Nature of Work: MP 1120 1 STORY 6 RM SFR

**RIVERDALE VILLAGE 1**  
 "THE LANDING" FOR BEAZER HOMES  
 PLOT PLAN FOR LOT 151

8810 SPARLING LN  
DIXON, CA 95620  
PHO: (707) 678-1636  
FAX: (707) 678-5757TO: **BEAZER HOMES**  
3721 DOUGLAS BLVD SUITE 100  
ROSEVILLE CA 95661  
(916) 7730425ANDERSON TRUSS  
JOB INFO:  
NAME: DING  
JOB #: n/a  
LOT #: 1151  
C/O #: AS04180601RE: PLAN 1120 @ RIVERDALE NORTH  
TRUSSES INSTALLED BACKWARDS

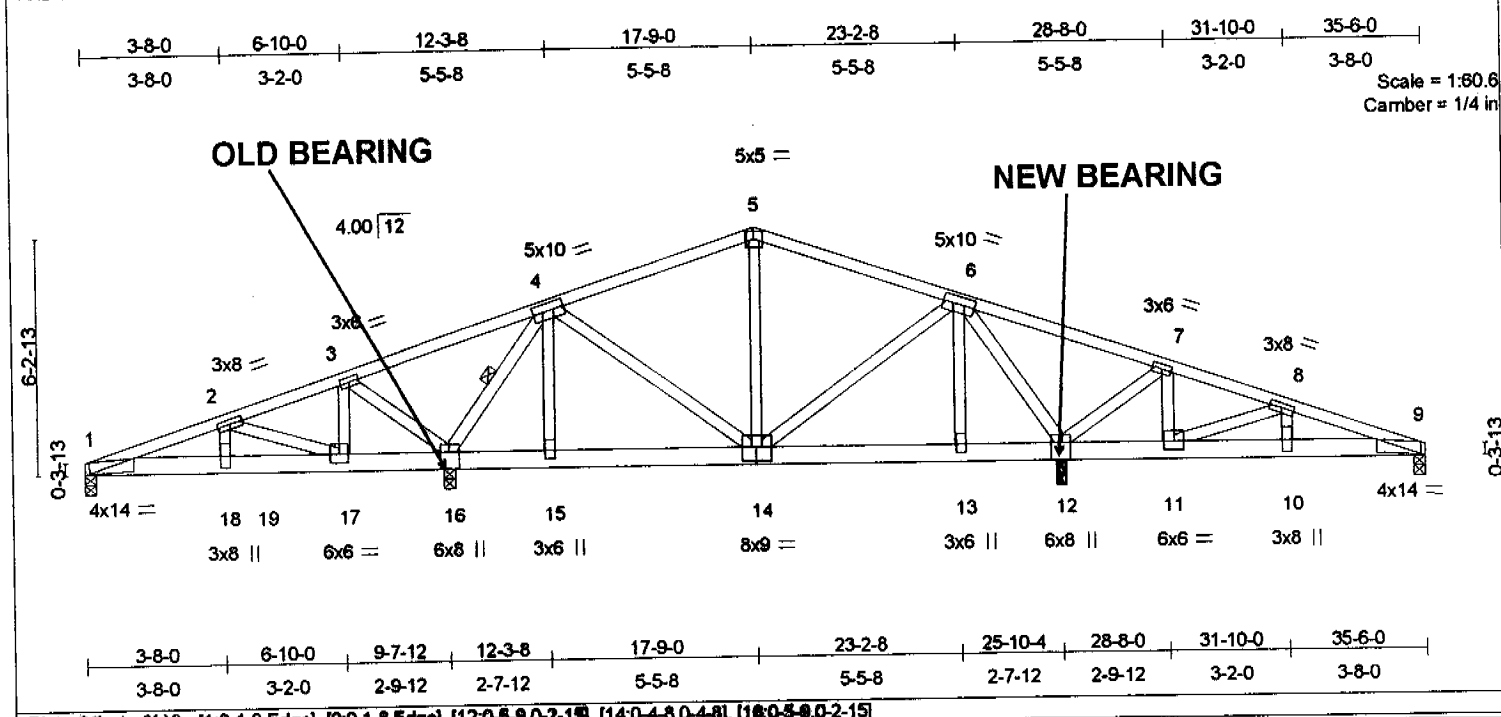
- A plate rating reduction of 20% has been applied for the green lumber members.
  - WARNING: Required bearing size at joint(s) is greater than input bearing size.

**NO REPAIR REQUIRED**  
 TRUSS MAY BEAR AT EITHER INTERIOR LOCATION POINTED OUT ABOVE.  
 TRUSS MUST BE THREE POINT BEARING, ONE AT EACH END AND ONE INTERIOR, SYMETERICAL DESIGN ALLOWS FOR THIS INSTANCE.

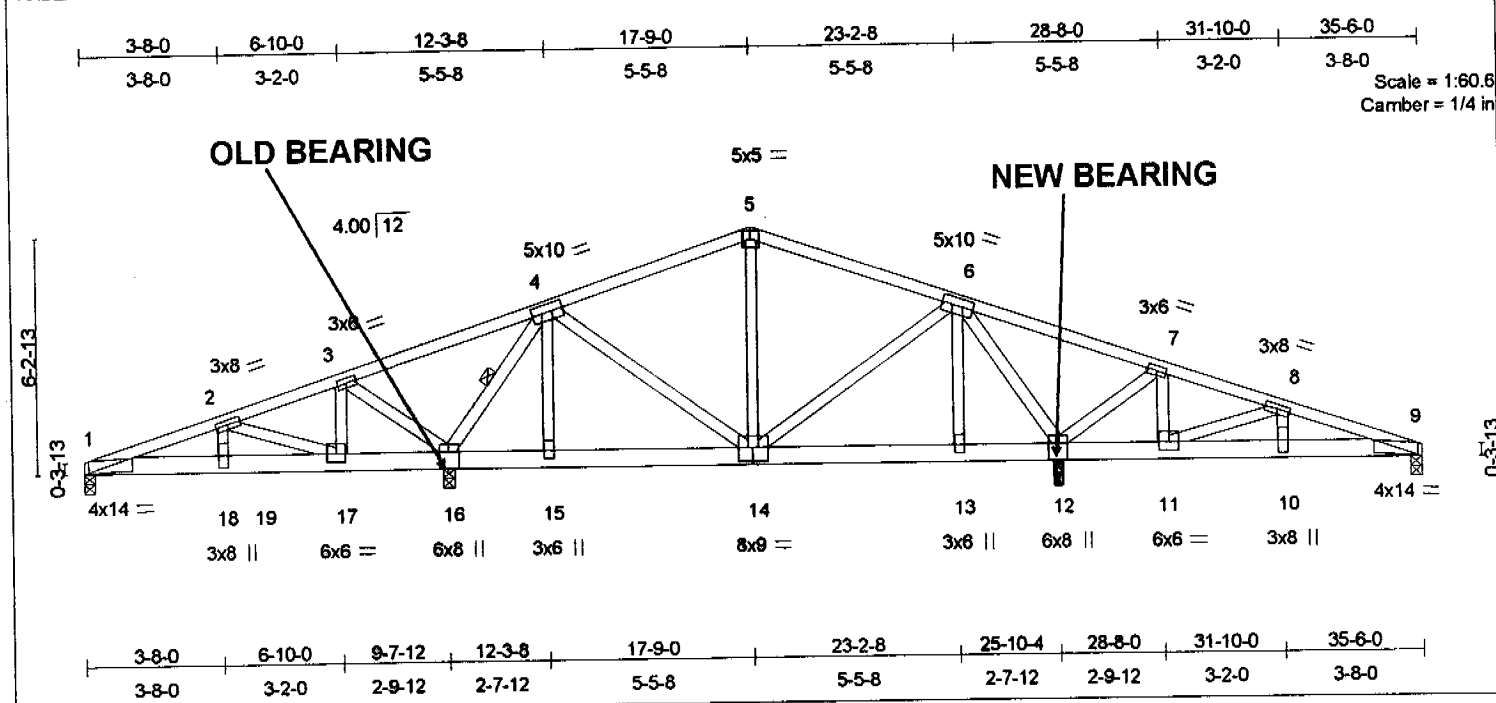
- A plate rating reduction of 20% has been applied for the green lumber members.
  - WARNING: Required bearing size at joint(s) 16 greater than input bearing size.

**NO REPAIR REQUIRED**  
**TRUSS MAY BEAR AT EITHER INTERIOR LOCATION POINTED OUT ABOVE.**  
**TRUSS MUST BE THREE POINT BEARING, ONE AT EACH END AND ONE**  
**INTERIOR, SYMETERICAL DESIGN ALLOWS FOR THIS INSTANCE.**

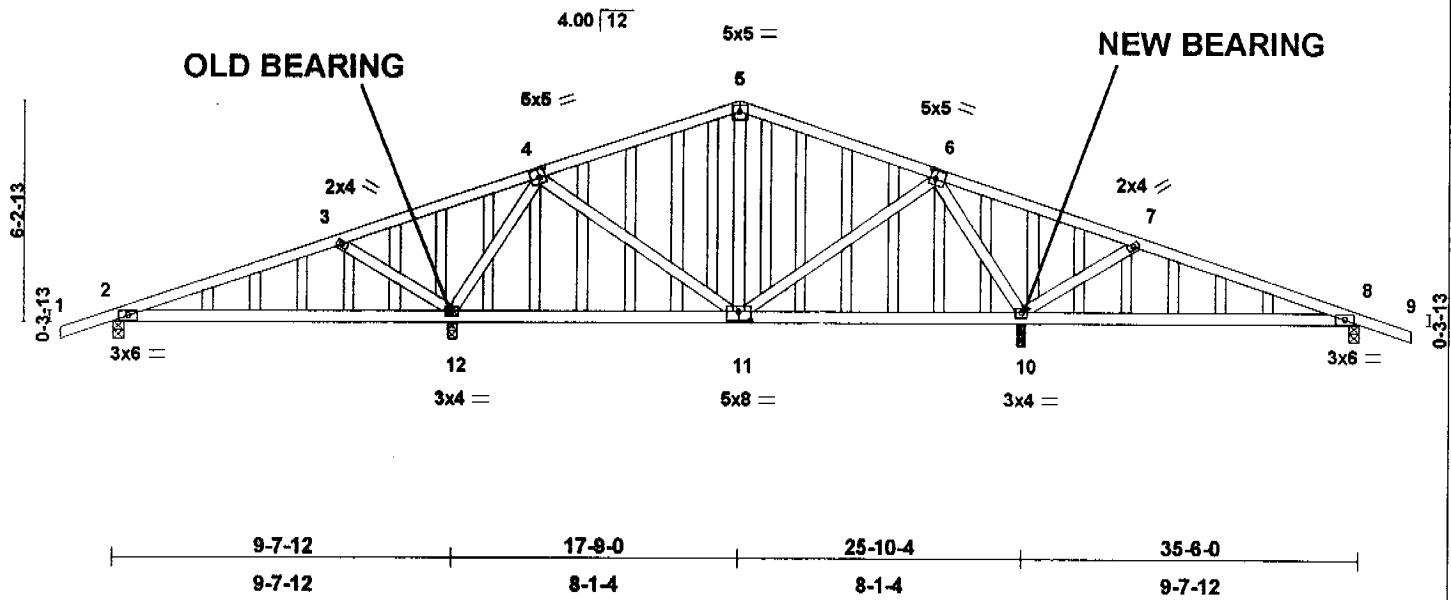
**NO REPAIR REQUIRED**  
**TRUSS MAY BEAR AT EITHER INTERIOR LOCATION POINTED OUT ABOVE. TRUSS MUST BE THREE POINT BEARING, ONE AT EACH END AND ONE INTERIOR, SYMETERICAL DESIGN ALLOWS FOR THIS INSTANCE.**

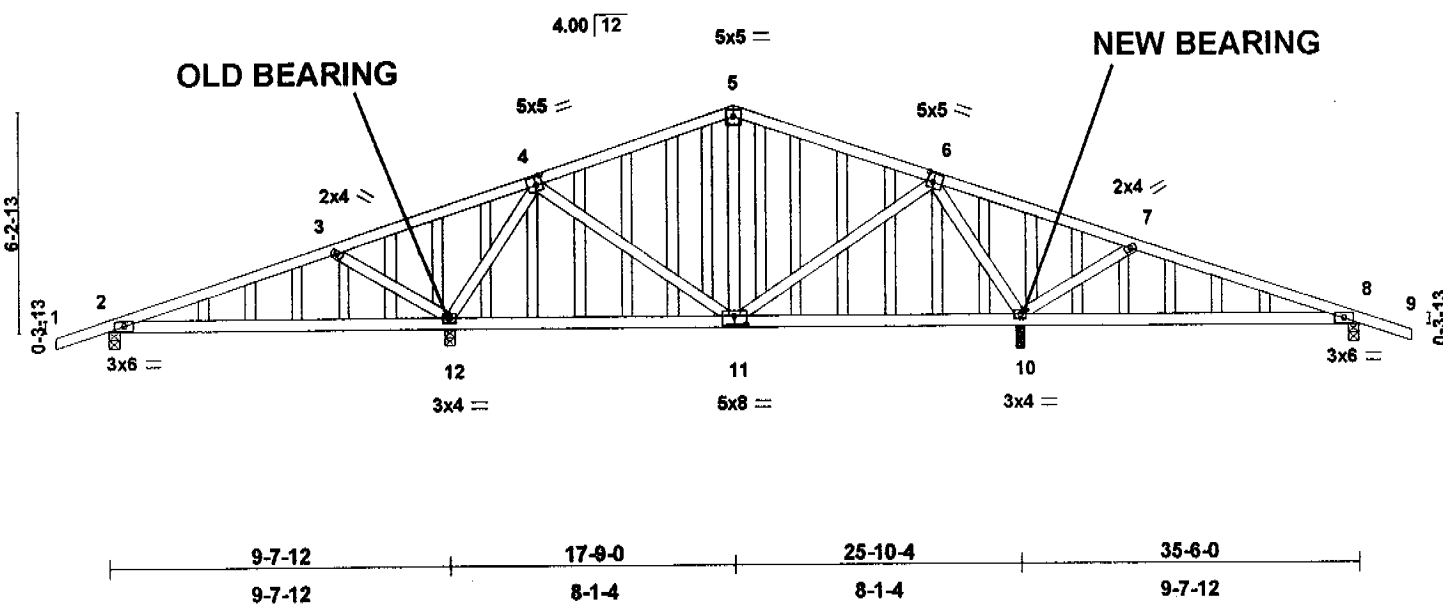
**NO REPAIR REQUIRED**  
**TRUSS MAY BEAR AT EITHER INTERIOR LOCATION**  
**POINTED OUT ABOVE. TRUSS MUST BE THREE POINT**  
**BEARING, ONE AT EACH END AND ONE INTERIOR,**  
**SYMETERICAL DESIGN ALLOWS FOR THIS INSTANCE.**

Job 1120	Truss BC1	Truss Type DBL HOWE	Qty 1	Ply 2	BEAZER / LANDING @ RIVERDALE 1120 COLLECTOR TRUSS #2900 Job Reference (optional)
ANDERSON TRUSS DIXON, DIXON, CALIFORNIA 95620			6 200 s Jan 10 2005 MITek Industries, Inc. Tue Aug 02 14:42:34 2005 Page 1

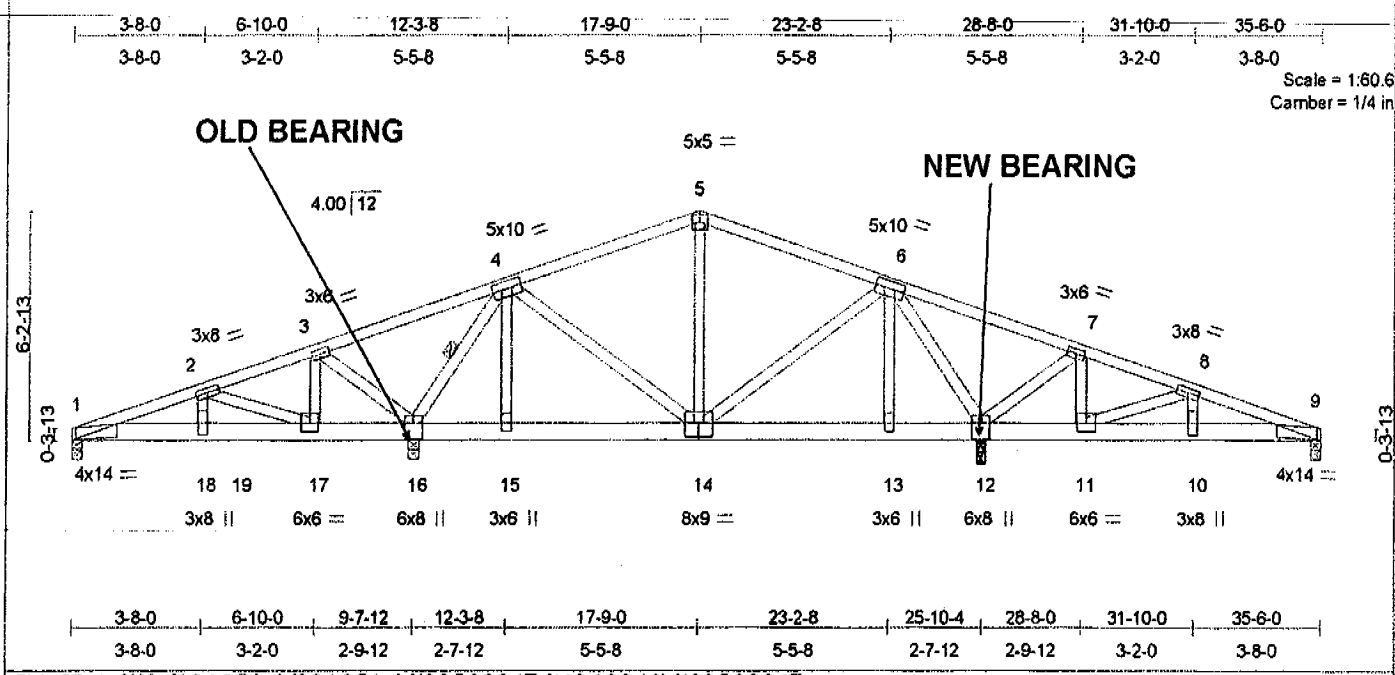
- A plate rating reduction of 20% has been applied for the green lumber members.
  - WARNING: Required bearing size at joint(s) 16 greater than input bearing size.

**NO REPAIR REQUIRED**  
**TRUSS MAY BEAR AT EITHER INTERIOR LOCATION POINTED OUT ABOVE.**  
**TRUSS MUST BE THREE POINT BEARING, ONE AT EACH END AND ONE**  
**INTERIOR, SYMETERICAL DESIGN ALLOWS FOR THIS INSTANCE.**
